Application No. 10/070,138
Amdt dated June 15, 2004
Reply to Office Action of February 17, 2004

Amendments to the Drawings:

FIG. 1

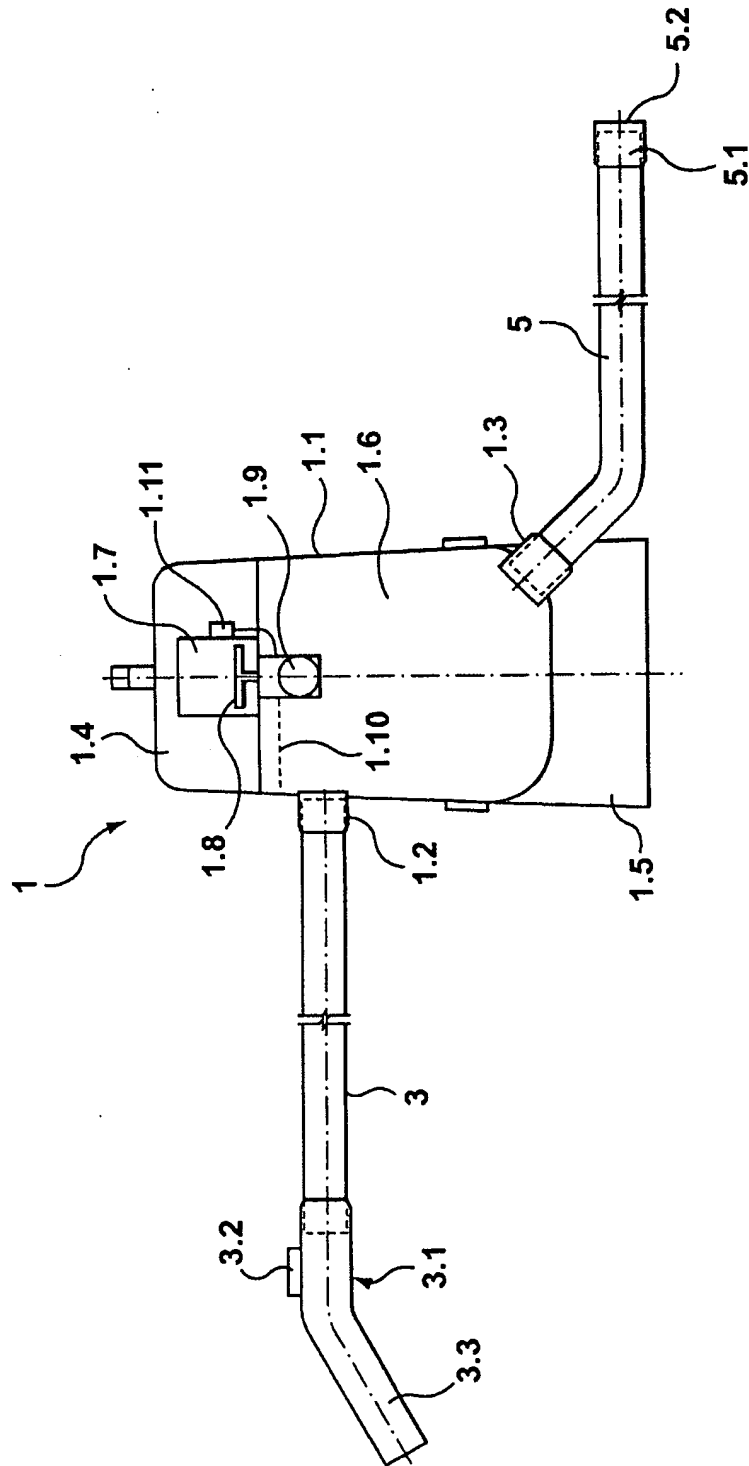
In Figure 1, one of the two previous reference character "1.7" has been amended to read "1.1". A filling limit has been added at reference 1.10. A sensor "1.11" for controlling the motor has been added.
